AMENDMENT OF SOLICITATION/MODIFICATION OF CONTRACT				1. CONTRACT ID CODE	PAGE OF PAGES	
				J	1	13
2. AMENDMENT/MODIFICATION NO. 0001		3. EFFECTIVE DATE 22-Aug-2006	4. REQUISITION/PURCHASE REQ. NO.		5. PROJECT NO.(If applicable) OM-06-065

14. DESCRIPTION OF AMENDMENT/MODIFICATION (Organized by UCF section headings, including solicitation/contract subject matter where feasible.) The above numbered solicitation for Atchafalaya Basin, Gulf Intracoastal Waterway (GIWW) and Miscellaneous Projects, Cutterhead Dredge Rental No. 1-2006, St. Martin and St. Mary Parishes, LA, is amended as shown on the attached pages. A BID OPENING DATE OF 28 AUGUST 2006, 11:00 AM LOCAL TIME AT PLACE OF BID OPENING, IS ESTABLISHED.						
Except as provided herein, all terms and conditions of the document referenced in Item 9A or 10A, as heretofore changed, remains unchanged and in full force and effect.						
15A. NAME AND TITLE OF SIGNER (Type or print)			16A. NAME AND TITLE OF CONTRACTING OFFICER (Type or print)			
			TEL:		EMAIL:	
15B. CONTRACTOR/OFFEROR _____ (Signature of person authorized to sign)		15C. DATE SIGNED	16B. UNITED STATES OF AMERICA BY _____ (Signature of Contracting Officer)		16C. DATE S

Sheet 1 of 3

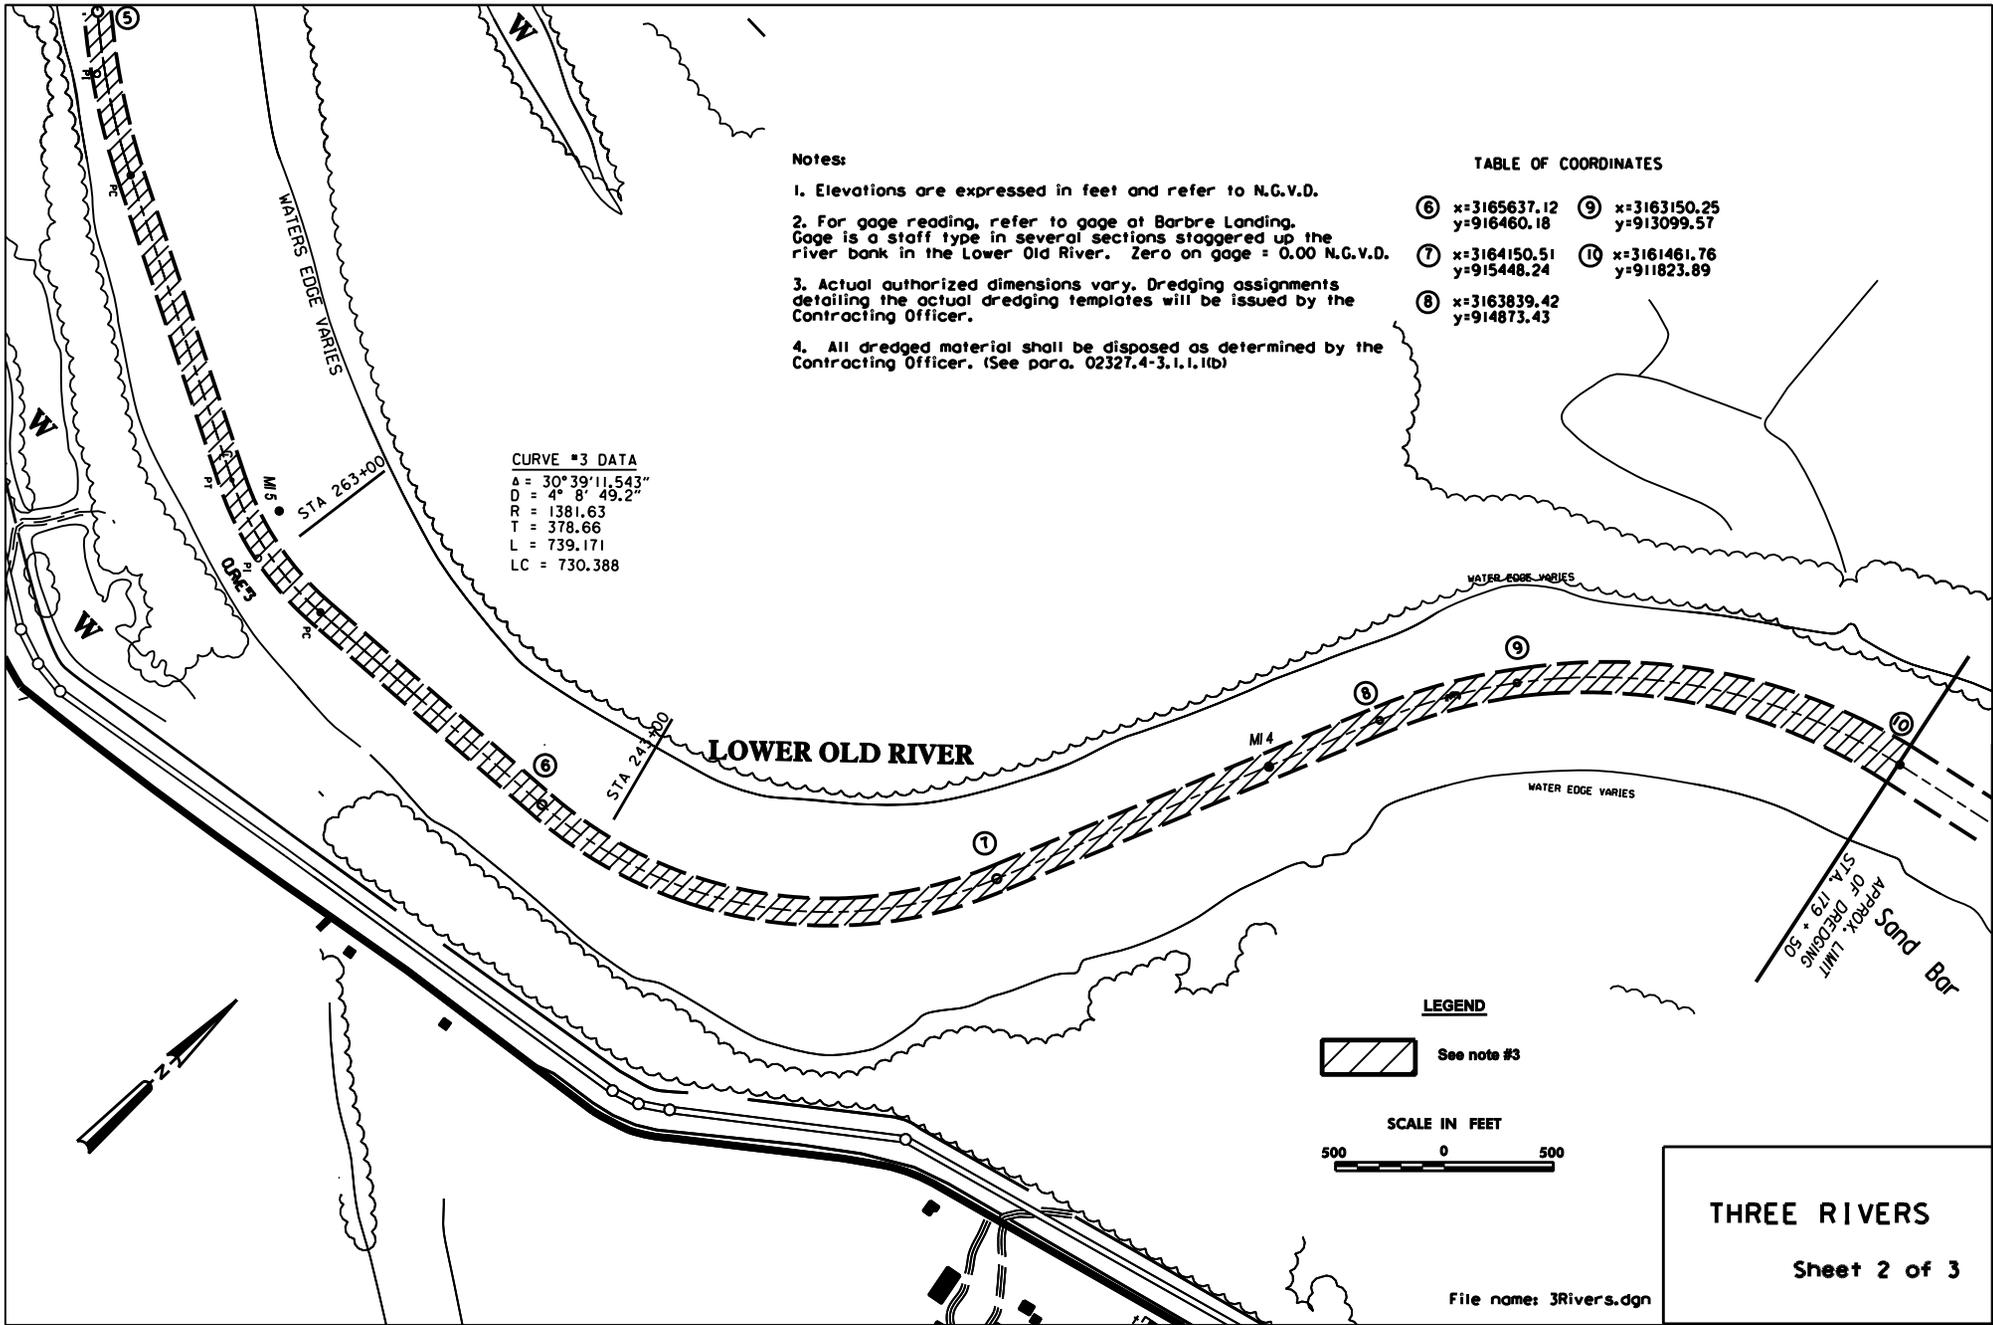
b. Delete pages 02327.4-3 and 02327.4-4 and replace with the attached pages 02327.4-3, 02327.4-4 and 02327.4-5.
